Eisenberg, February 26<sup>th</sup> 2018

**Safety note concerning: Deployment bags for reserve parachutes**

**Status: OBLIGATORY**

### CONCERNED DEPLOYMENT BAGS

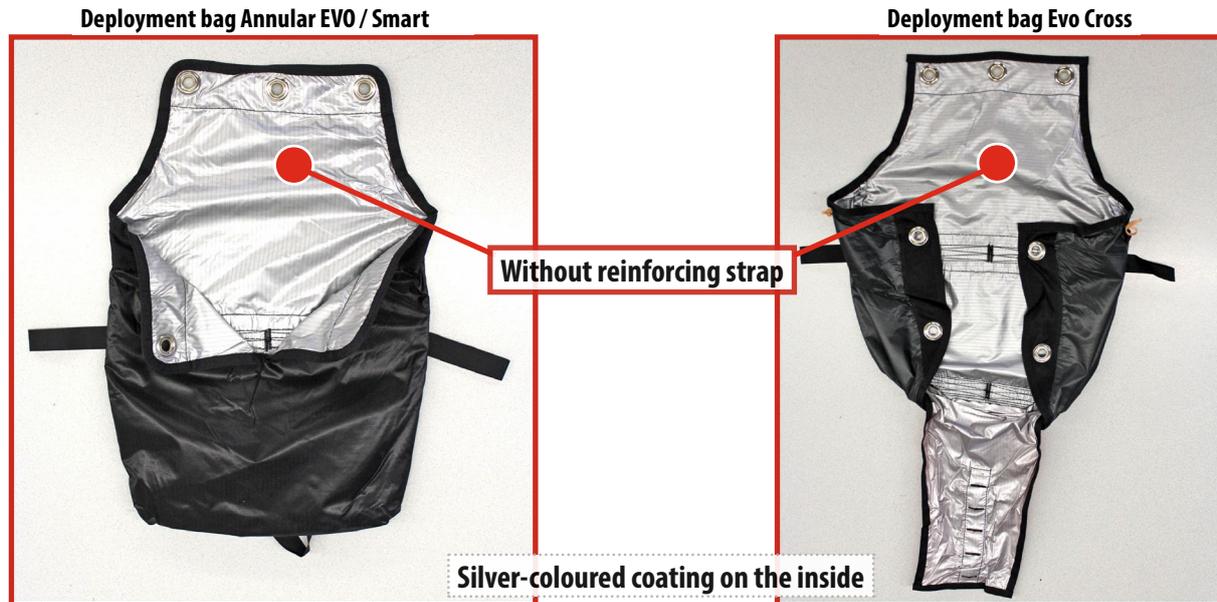
At the seam-line of the isolated upper loop, which is used to attach the deployment handle, a perforation could possibly cause a material weakening of factory delivered deployment bags. This seam-line, if properly processed, has to be able to bear a load of 70 daN. Yet it was proven that a lower strength of this component can occur.

The affected deployment bags can be distinguished either by the year of manufacture or their serial number. The best visible indication which distinguishes concerned bags, is their silver-coloured coating on the inside of the deployment bag, if it does not have a reinforcing strap (as can be seen below).

Please check immediately whether your deployment bag is part of the concerned production lot. We are sorry for the inconvenience caused and thank you for your understanding and cooperation!

### DEPLOYMENT BAGS NOT CONCERNED

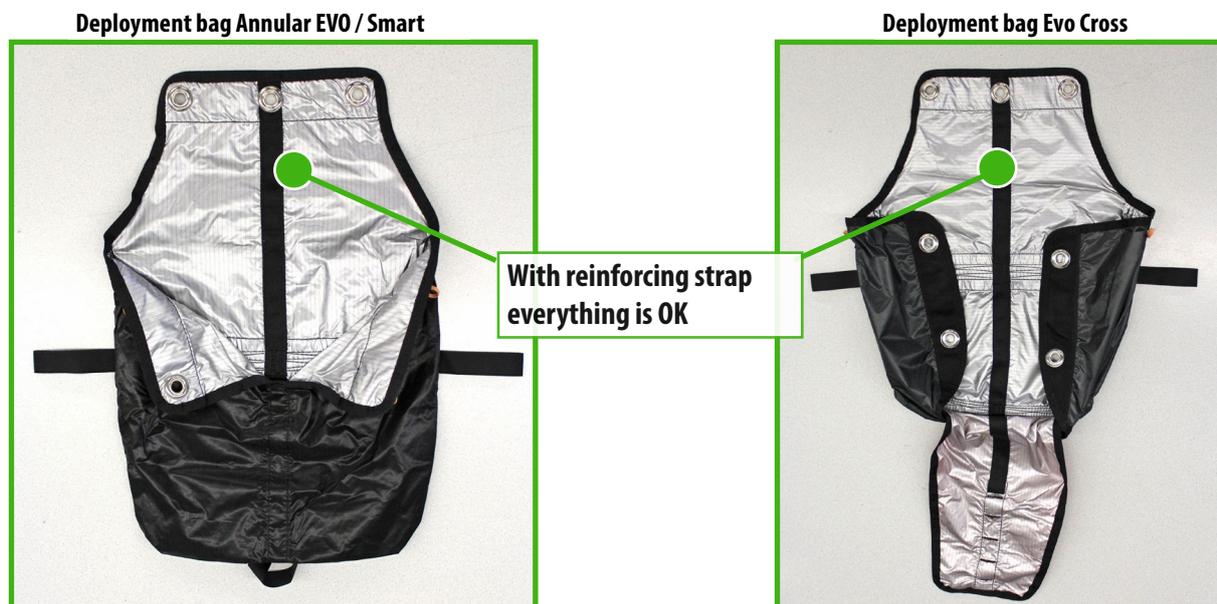
Not concerned are earlier items which can clearly be recognised by the missing silver-coloured coating on the inside. Not concerned are all items which have been delivered as of February 2018. These new deployment bags are clearly marked with a check mark (OK) and can be recognised by the additional reinforcing strap on the inside. Furthermore deployments bags which have been delivered as component of a harness are not concerned.

## Procedure:

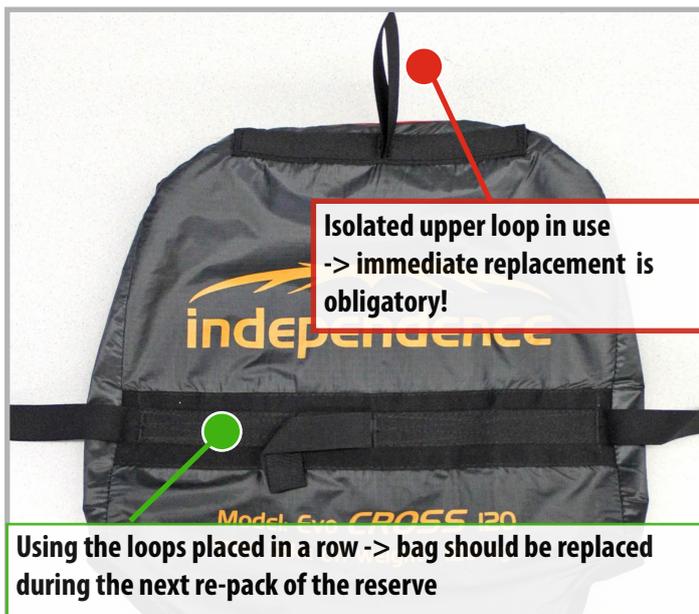
The owners of affected deployment bags are obliged to check before flight, whether the **isolated upper loop** of the deployment bag is in use. If it is in use, the deployment bag needs to be replaced immediately!

If one of the **three loops in a row**, which are placed between the labellings, is in use, the deployment bag does not necessarily need to be replaced. **These three loops don't show any faults and are not concerned by this safety note** (see image on the left).

Of course we do replace all concerned deployment bags by reinforced items, even if the affected loop is not in use!

If the isolated upper loop is in use, **immediate replacement** is obligatory!

If one of the lower 3 loops placed in a row is in use: Replacement should take place latest during the next re-pack of the reserve.
